Board of Zoning Adjustment for the District of Columbia

This statement is submitted by the appellants, who reside within 200 feet of the subject property, 1636 Argonne Place NW. As is outlined in detail in this pre-hearing statement, the Zoning Administrator violated multiple zoning regulations in approving building permits B1502210, B1404813 and B1409928 (including the revision to permit B1404813, issued 6/19/15 per RW1500079 and B1509180, issued 6/24/15) and associated construction drawings for the subject property, a single-family dwelling undergoing conversion to a multi-unit condo building.

BZA 18980 – 1636 Argonne Place NW – Submitted 6/23/15 – Amended 6/25/15

A Series of Attempts to Alter FAR Calculations of the Lower Level

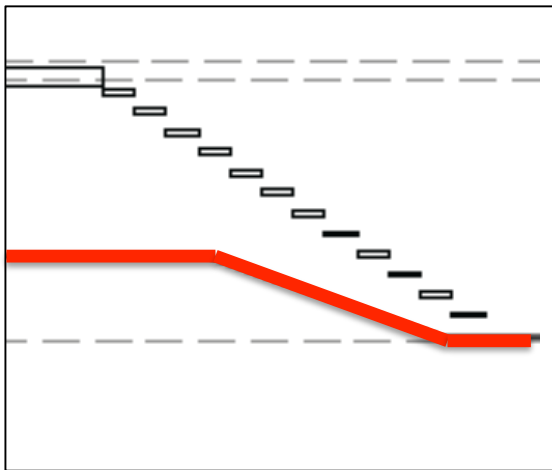
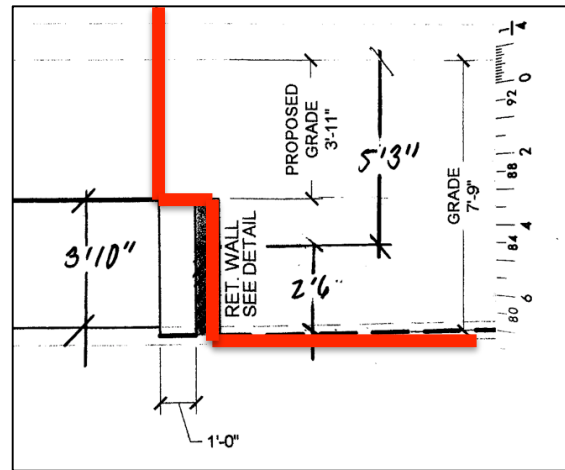
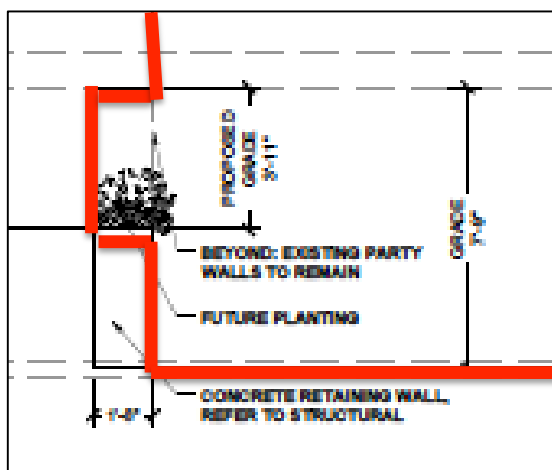
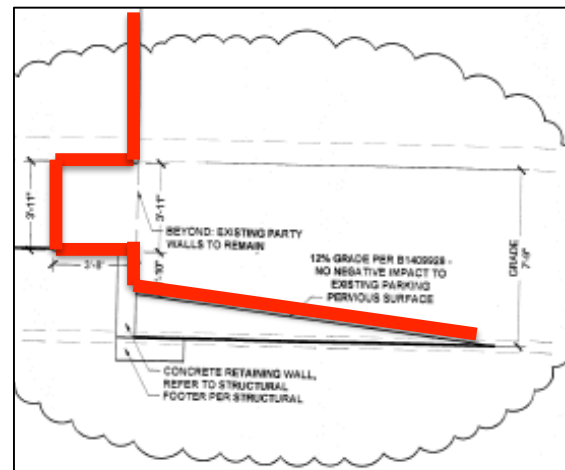
As for errors in grade definitions, these manipulations (see page 5) comprise a disregard of actual conditions (including depiction of a non-existent berm) and a bizarre set of three planters/retaining wall options, whose tops are proposed to serve as (and yet un-built) grade for purposes of determining lower level cellar/basement status. At each point, initially as neighbors and later as appellants, we have pointed out actual and existing conditions. At each point, drawings been changed, repeatedly, in apparent pursuit of an impossible solution: a redefinition of the plain meaning of zoning regulations governing existing, proposed, and grade.

The latest series of changes can be found in B1509180 (hereinafter referred to as June 2015 Error). This permit replaced an earlier set of 1/8/15 and 3/24/15 revisions (hereinafter termed Jan-March 2015 Permit Revisions), whose attempt to circumvent the zoning regulations definition of existing grade created a ripple effect in the form of a series of parking and rear yard violations documented by appellants in our initial pre-hearing statement.¹ B1509180 is a permit to construct an as-yet un-built retaining wall proposed to be embedded within the building itself. This represents a frontal assault on the accepted definition of grade as a location external to the building façade. Clearly, any point on this non-existent embedded wall is irrelevant on determining the status of the lower level as a cellar/basement and a story below/above grade. Finally, as if the case is not made by the clear logic of what is meant by grade, the embedded retaining wall does not exist and thus cannot serve as a reference point for determining basement/cellar status of the lower level.

A0100 (6/4/15)

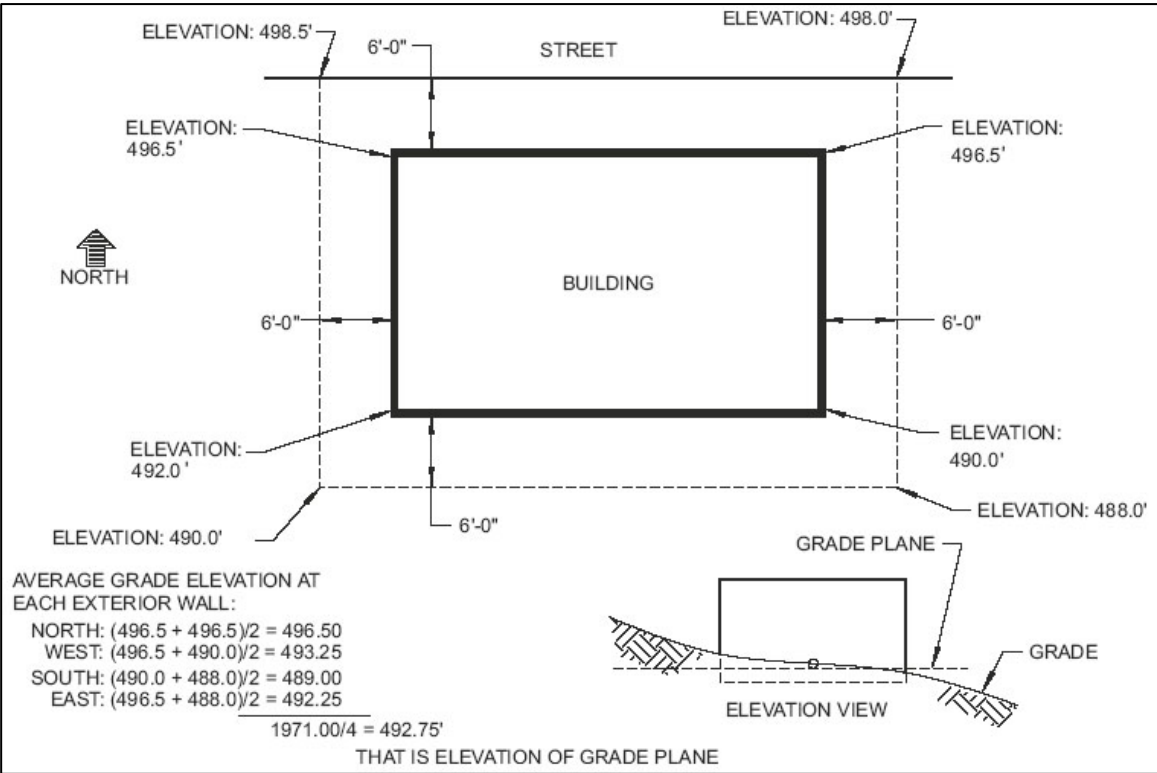
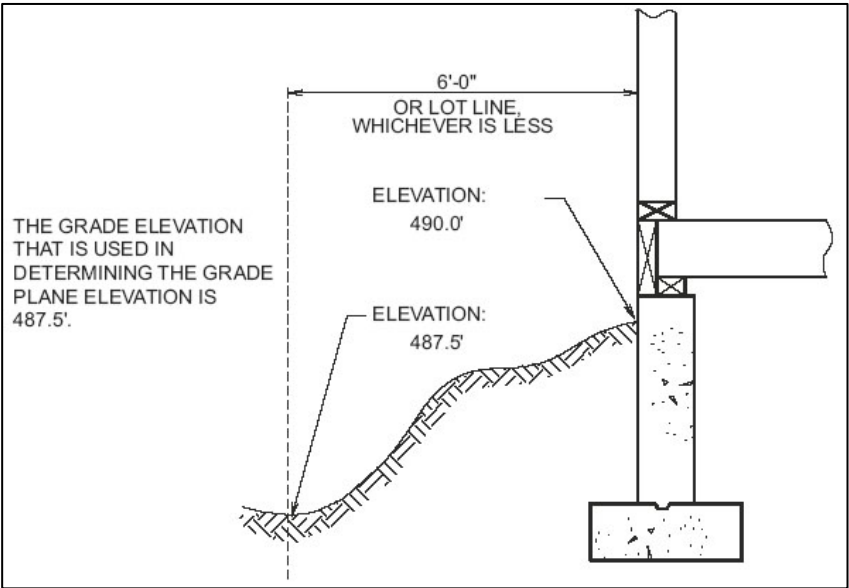
This entryway, created in a 2002 renovation, is directly below the front porch. The entryway extends across the entire width of the building (20') and 7' 1 ¼" in depth as measured from the front of the building (i.e., the basement apartment and its front door) to the face of the exterior wall of this entryway. On the other side of this exterior wall is the unfinished grade of the front yard. This exterior wall has a locked gateway leading up to a set of steps that terminate at the finished landing for the building.

This 5' standard for an areaway is additionally supported in the IBC's grade plane analysis, which defines the “true” point for which to establish a story above and below grade as 6' beyond the exterior wall for buildings where grades fall away from the exterior walls (see below diagram). For the subject property, the entryway qualifies as the adjacent finished grade as it is 7' 1 ¼" wide from the face of the building's front wall to the face of the area's retaining/exterior wall, which is both wider than the 5' areaway standard and IBC's 6' point of measurement standard.

FRONT GRADE – Sheet A0202

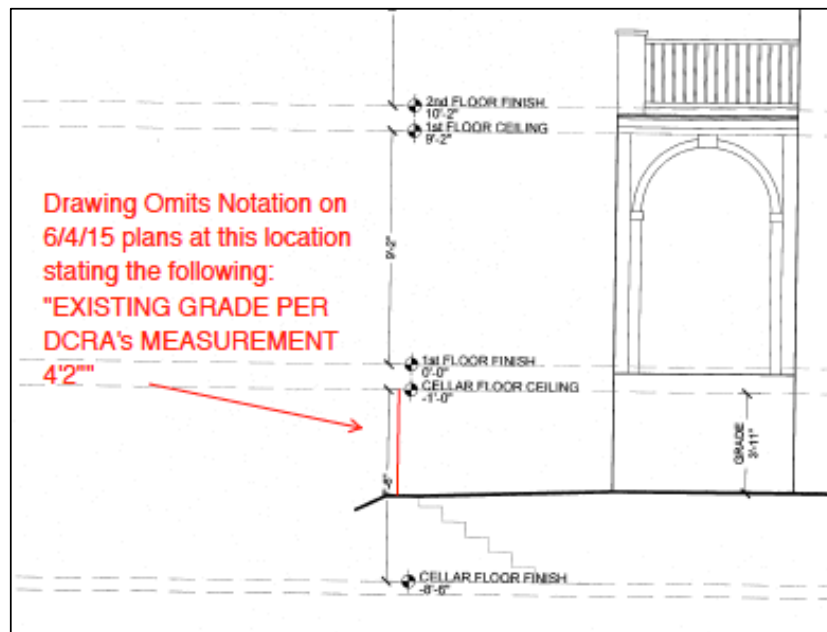
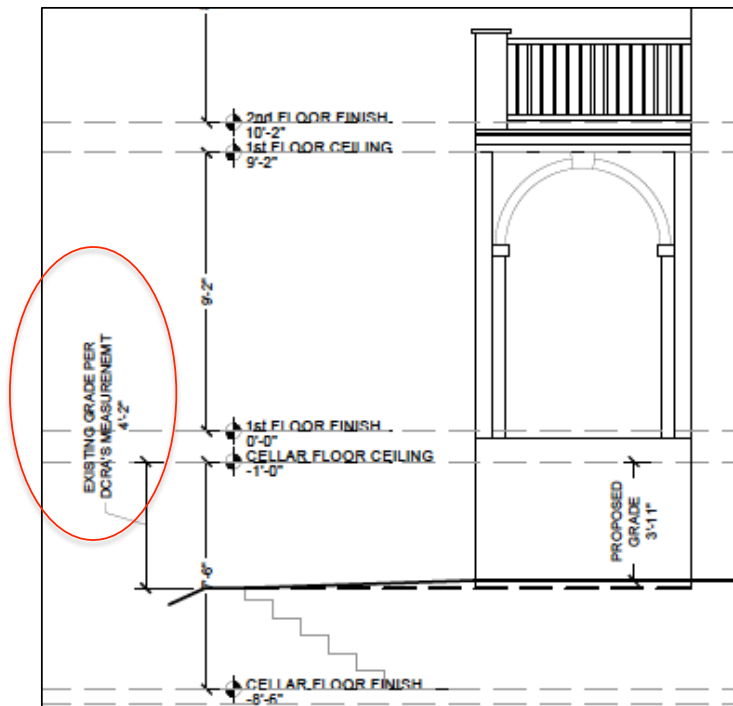
- **6/4/15 Revised Plans: Front Entryway Grade.** Architectural plans dated 6/4/15 identify the front grade as “EXISTING GRADE PER DCRA’S MEASUREMENT 4’2” (basement perimeter). At this point, the debate should be settled as to whether the front perimeter is basement or cellar. Nonetheless, the plans go on to depict at point under the first level porch (the entryway, the true adjacent finished grade as described above) as “PROPOSED GRADE 3’11””. The depiction is both irrelevant and incongruent with building plans as (1) the entryway is the adjacent finished grade as described above; (2) this grade is “proposed” and is thus irrelevant for purposes of establishing the basement/cellar designation; and (3) misrepresents the site conditions as this space is proposed to become part of the lower level unit and entryway to the lower level and would thus be impossible to berm over to achieve this measurement (see Tab T: Existing Conditions June 2015 and Tab U: Front Rear Parking Drawings June 2015).

Top: 12/17/14 Drawing Includes Reference to Existing Grade

Bottom: 6/4/15 Drawing with B1509180 - Excludes Reference to Existing Grade

12/17/14 Revised Plans: Front Entryway Grade. Architectural plans dated 12/17/14 identify the front grade as “PROPOSED GRADE 3’11”” and “EXISTING GRADE PER DCRA’S MEASUREMENT 4’2””. The actual front grade is 8’ at the entryway. As described above, “proposed” as a point of measurement is irrelevant and incongruent with building plans.

Multiple errors have also occurred with regard to the Zoning Administrator’s efforts to alter the definition of the existing grade at the rear of the building. These errors relate to a sequence of schemes to create a new grade.

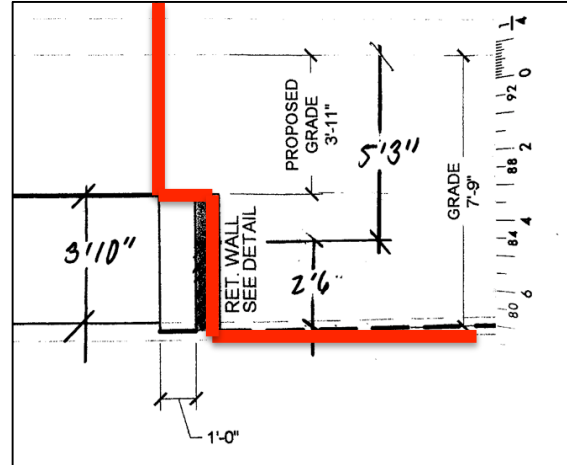
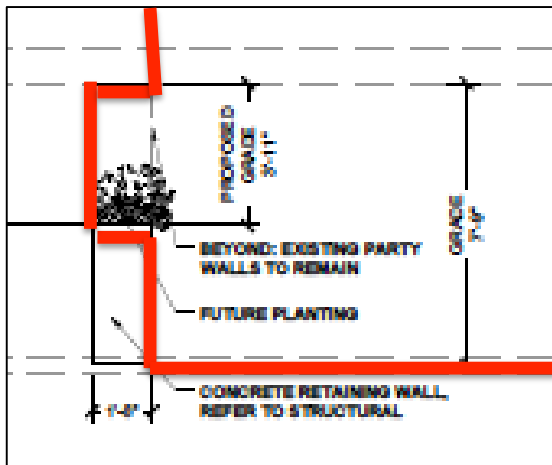
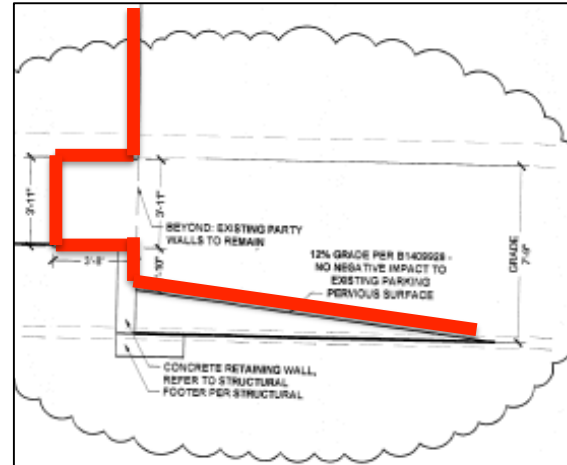
- The latest was B1509180 to define the grade as the bottom lip of an un-built notch within the building).
- The earlier attempt was through the 12/18/14 permit (issued 3/24/15) to construct a “retaining wall” (also un-built) against the back of the building, abandoned as an effort to create a new grade per a 5/7/15 Zoning Administrator determination.

- **June 2015 Misidentification of the Grade as the Lower Lip of an Embedded Notch/"Retaining Wall."** The Zoning Administrator granted B1509180 to create a notch within the back building wall, defining this structure as a retaining wall and defining the grade as the lower lip of this notch, which (if actually built) would be a point within the actual building. However, accepted definitions for grade (a term not explicitly defined but rather referenced in multiple and interrelated definitions) do not support the definition of grade as being anywhere but at the base of the wall, which is a point external to the building façade. If measured from the point that is external to the building façade, the grade is basement in all scenarios. The first is existing conditions, where the distance is 7'9". The second is proposed conditions, the proposed and un-built (i.e., not existing) slope, where the distance is 5'9" (see Tab U: Front Rear Parking Drawings June 2015).

**2014 Construction Drawing of Rear Grade
Depicts Berm/Slope That Does Not Exist**

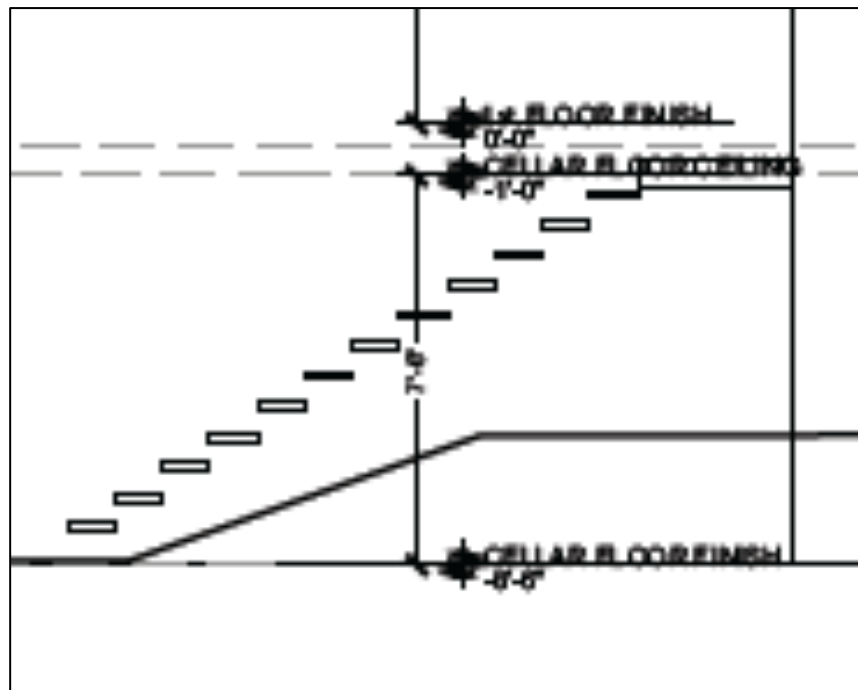
Errors were identified in initially submitted architectural plans dated 6/24/14, which do not provide dimensions for the rear grade but do show an incorrect existing grade (see below and Tab B: Existing Conditions and Tab S: Front Rear Parking Drawings) and an incorrect proposed grade. Even with these errors, the rear grade is 5'—basement perimeter.

June 2015 Error: Building Height: Front

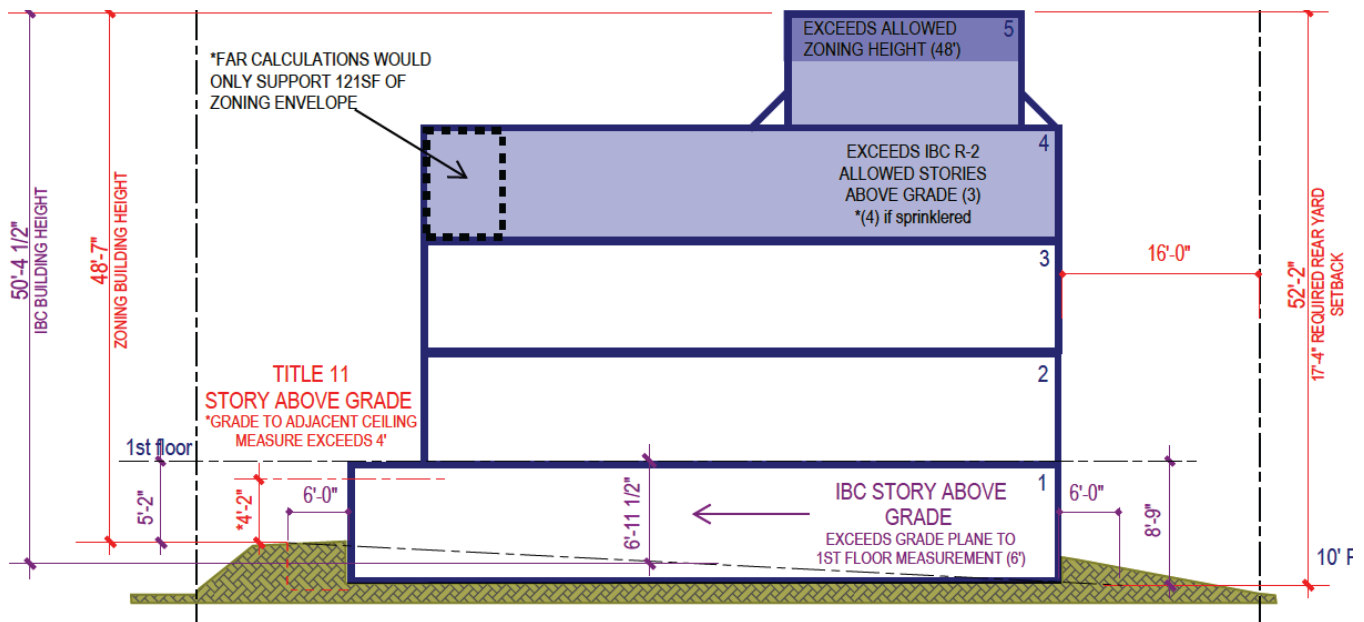
The cover sheet data indicates an existing building height of 44’-0 ¼”, which by the data on the sheet leaves a ceiling of lowest level to grade dimension of 4’-5 ¼”. This coincides with measurements taken on-site but differs from DCRA’s measurement of 4’-2”. Although a proposed grade of 3’-11” is shown for obvious purposes, the grade is shown where an entryway exists that is not possible to achieve.

The actual building height, as it should be measured in the R-5-B district, is 48’-7”. Based on this measuring point, the lowest level can be determined to be a story above grade and therefore countable towards FAR. Because the ceiling is greater than 4’ (7’-9”) from the existing grade at the rear of the building, the entire story should be considered above grade and therefore countable as FAR.
